Testimony before RI Office of Energy Resources Public
Workshop Regarding the Climate Change Impacts of the
proposed Burrillville Power Plant

Peter Nightingale
nigh@pobox.com

July 24, 2016

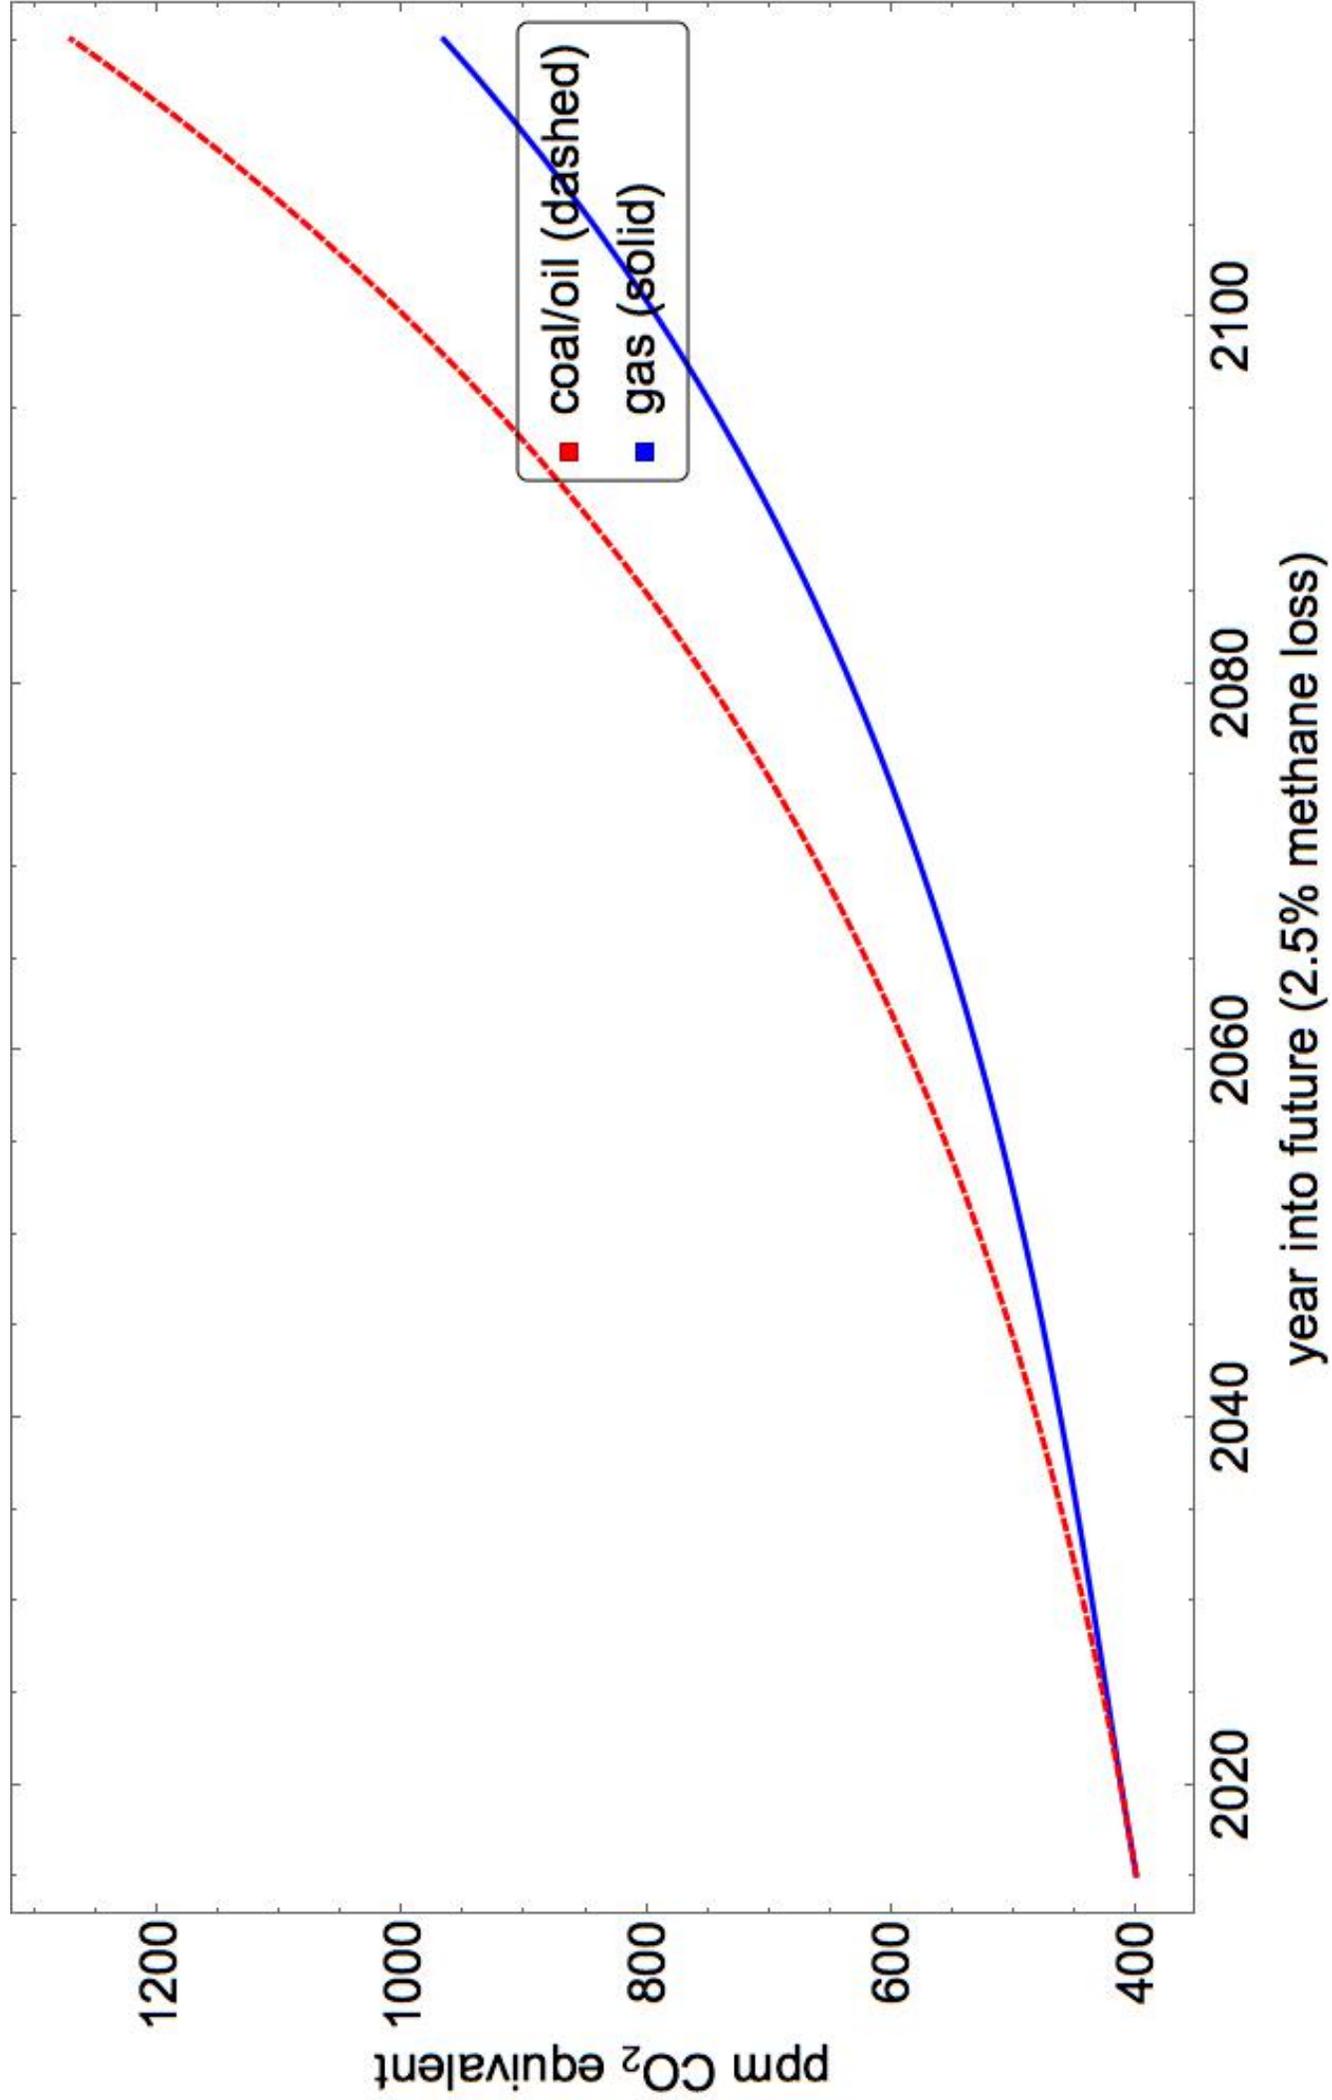
The quote from *Nature's Trust* at the top of this testimony fits perfectly with the OER presentation. The bar graph presented on page 21 of this document <http://tinyurl.com/gmgushz> is a demonstration of how this works. The disclaimer at the bottom

of the graph reads: “Note: Does *not* consider full life-cycle GHG emissions.” This makes the information presented totally irrelevant for global warming. The situation is even worse than the wrong estimates of the global warming potential used by the EPA. What OER creates here here Kahneman refers to as the *illusion of validity*.

Not surprisingly, this is exactly the method Invenergy uses to pretend that its proposed plant reduces greenhouse gas emissions as it does on page 15 of this presentation—

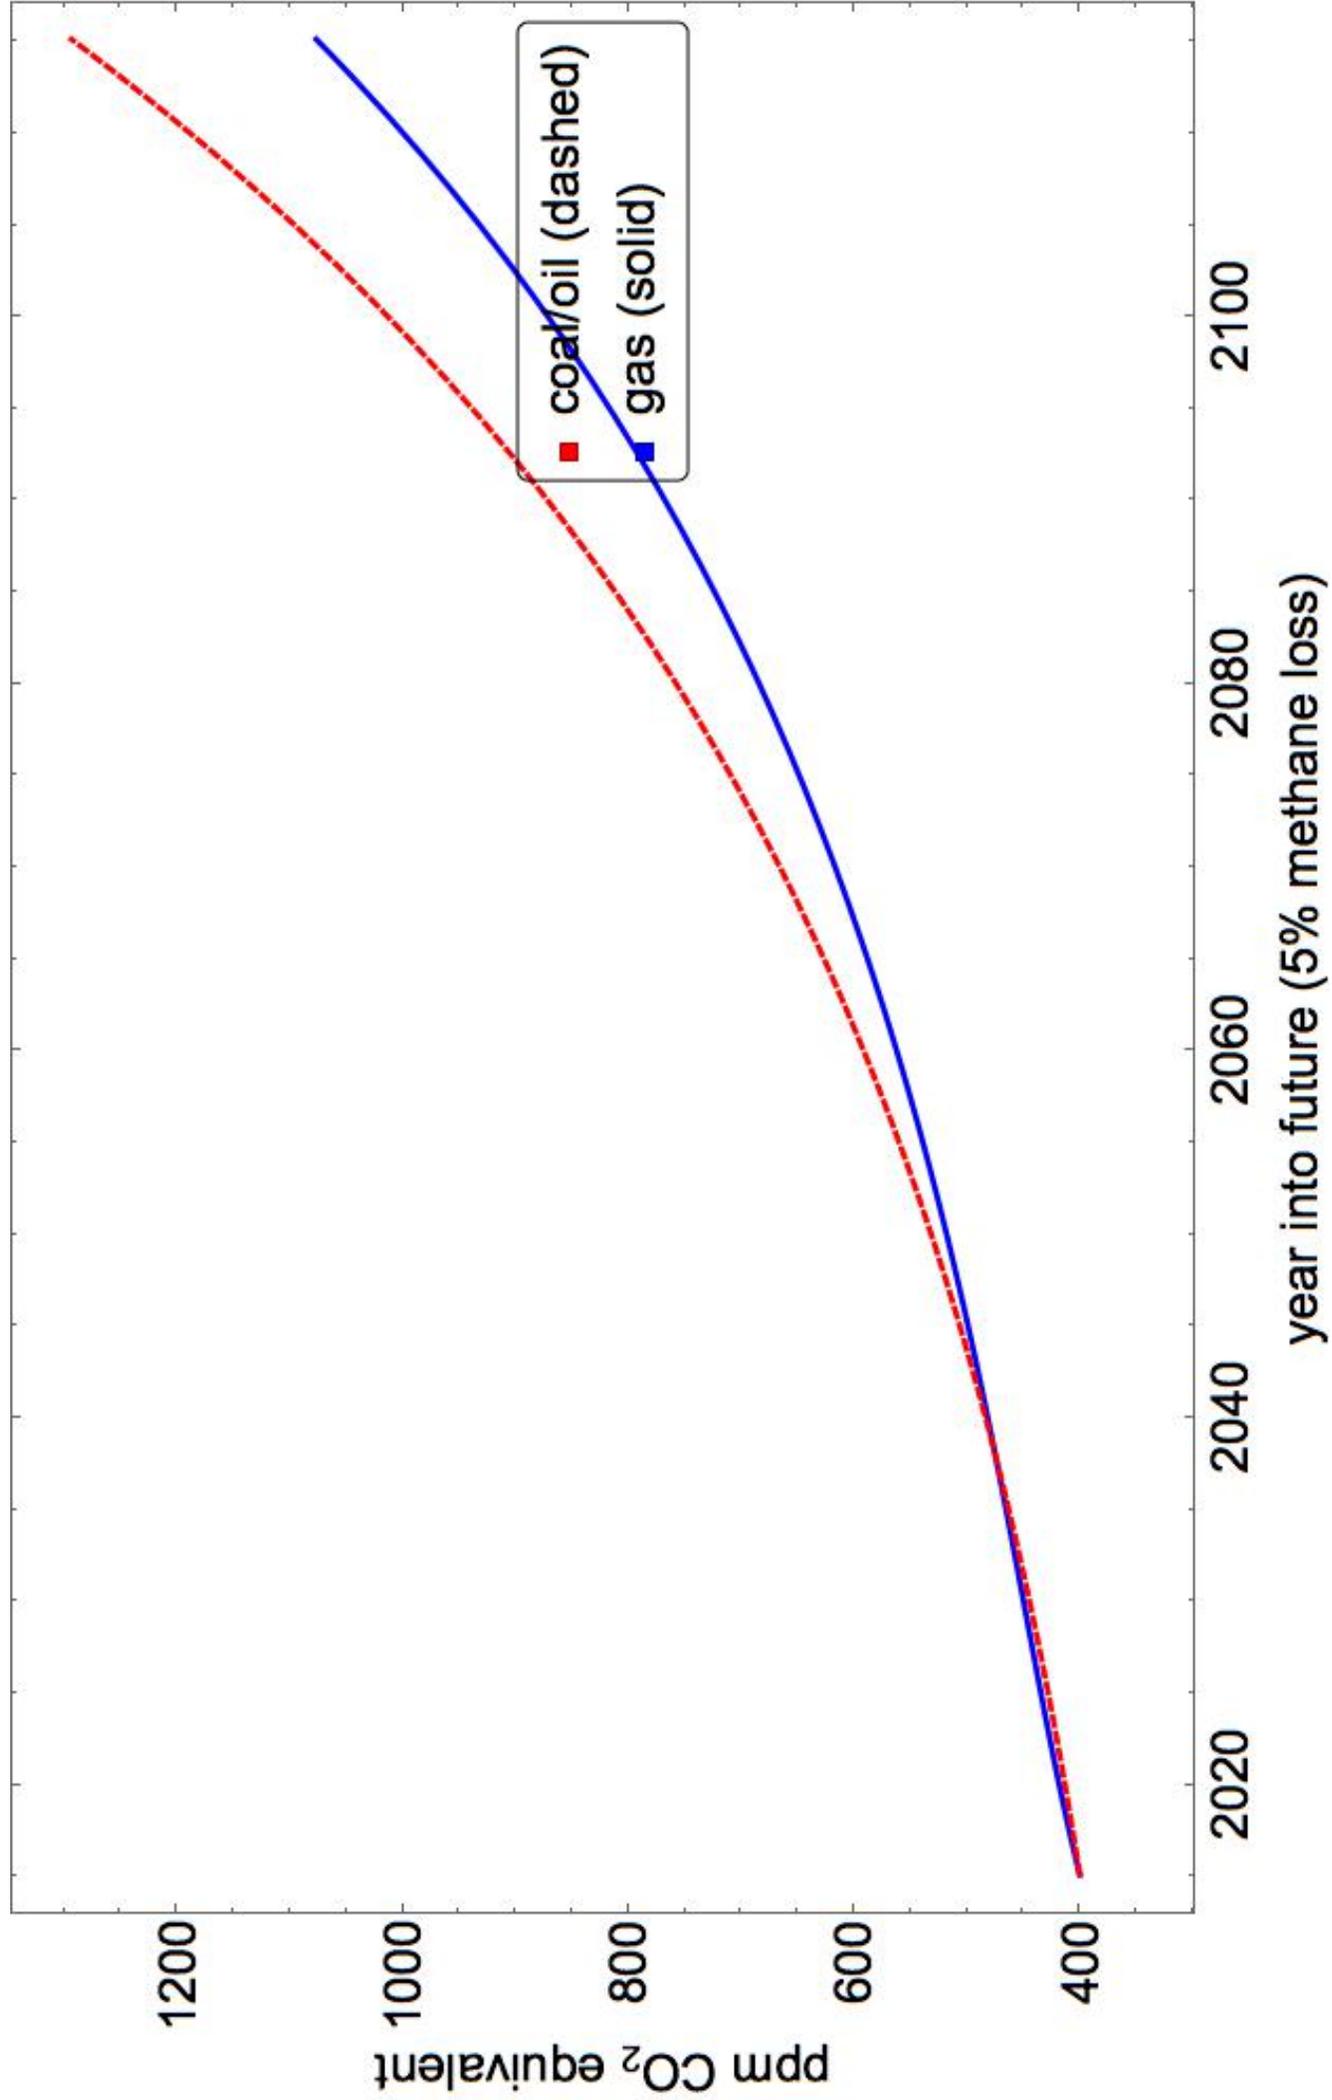
The only difference is that Invenergy fails to include a disclaimer.

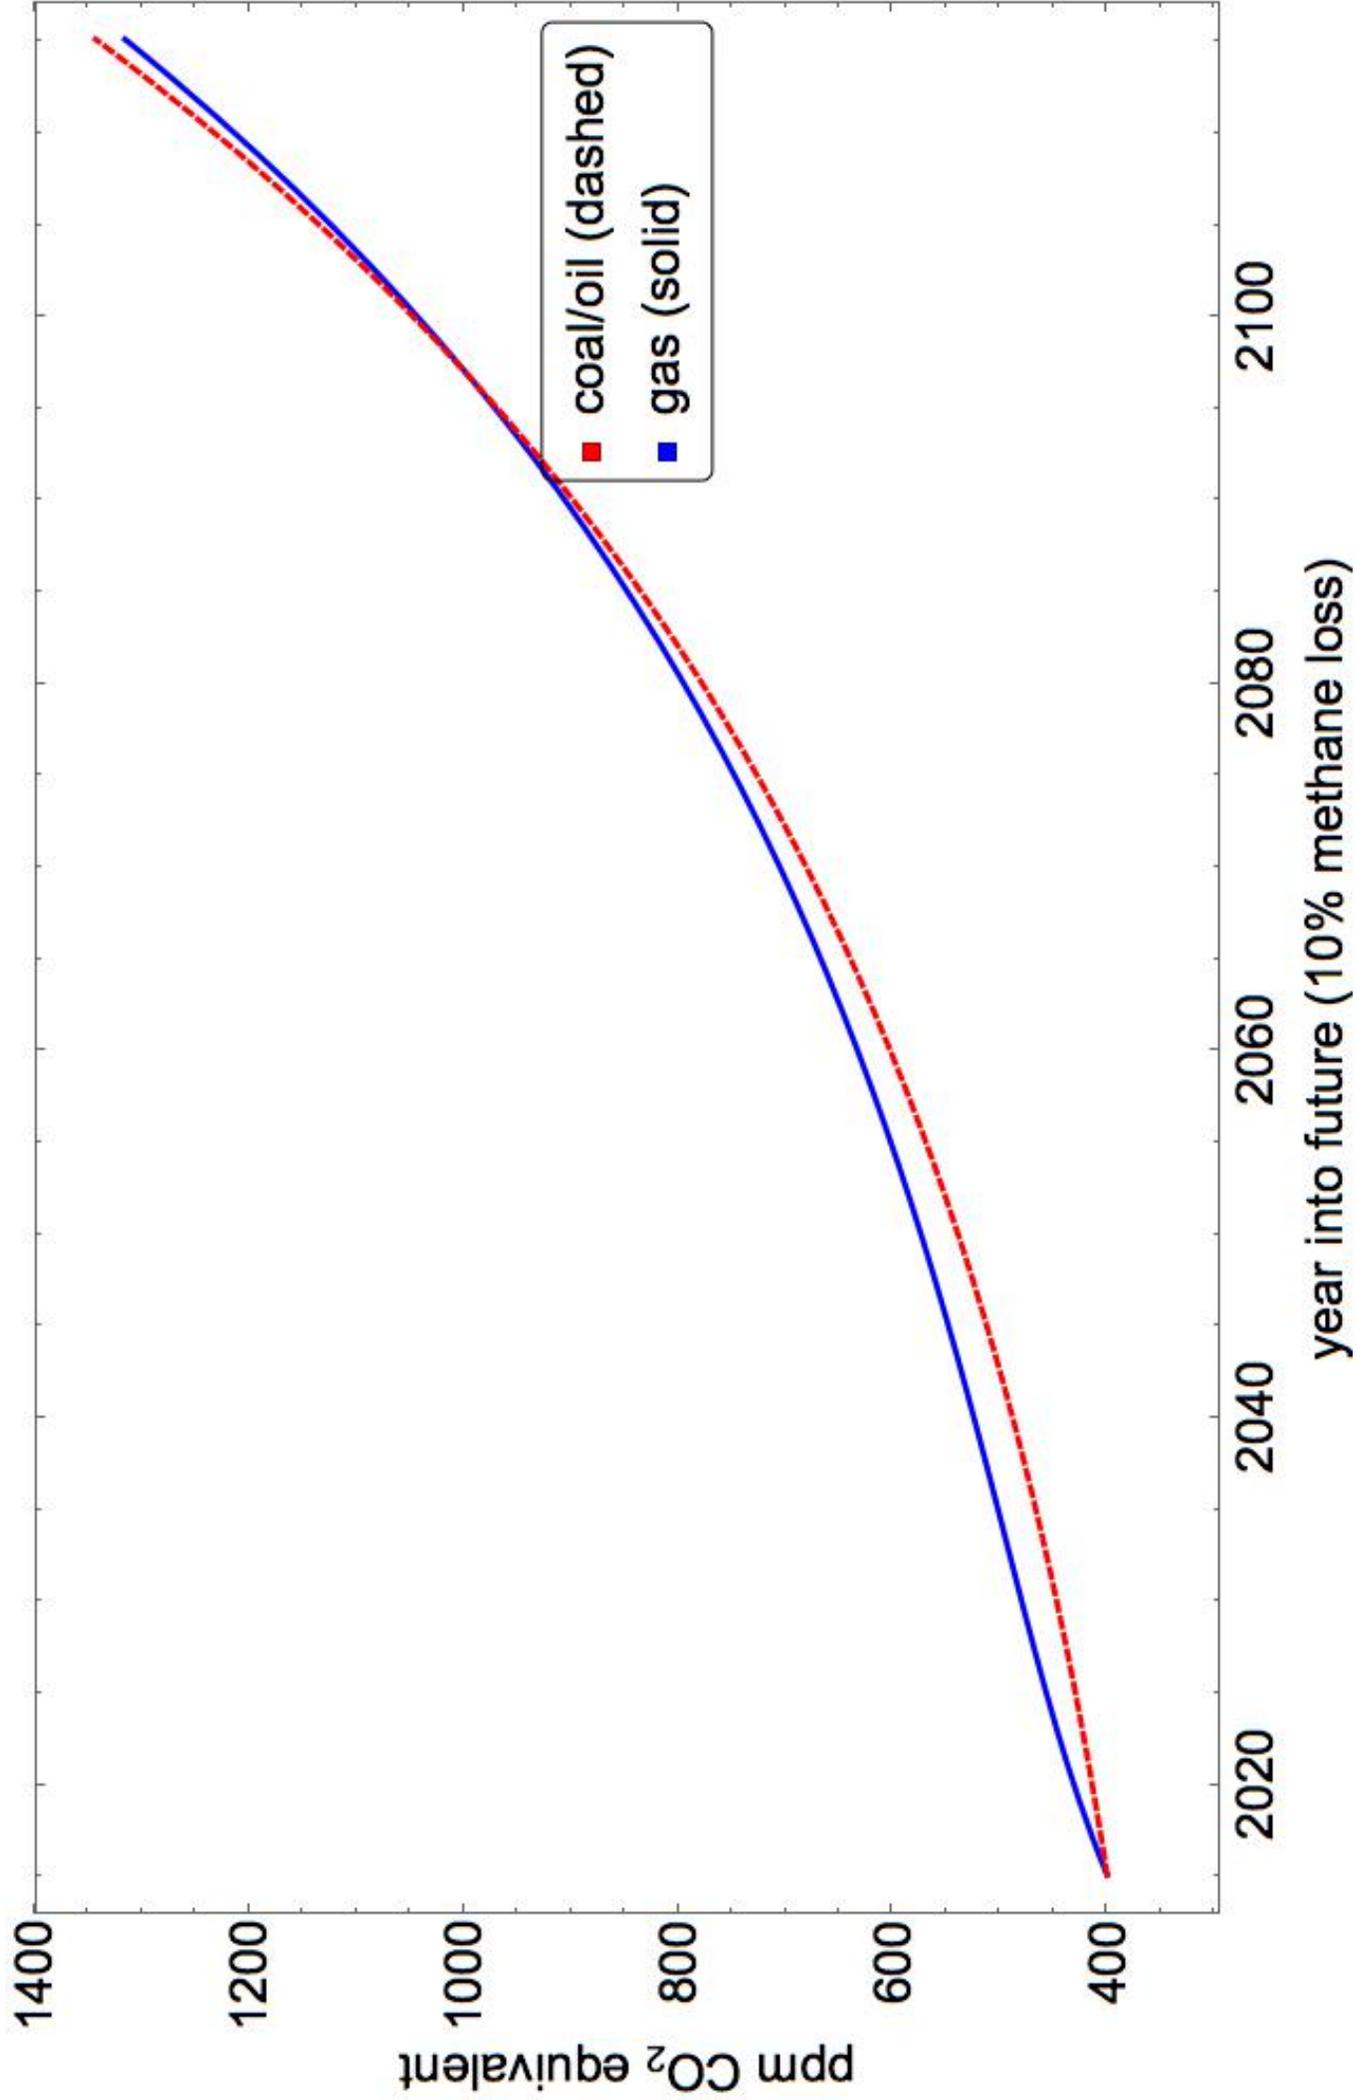
The next three pages contain some plots illustrating the impact of escaping methane. We look at the hypothetical, “ideal” implementation of the *Clean Power Plan*: the effect of switching power generation from only coal and oil completely to natural gas today assuming that energy consumption keeps growing according the pattern it has followed over the last 250 year, increasing by 2.2% per year.

There are three plots corresponding to 2.5%, 5% and 10% methane escaping unburned. Howarth’s latest estimate is that 12% is escapes—
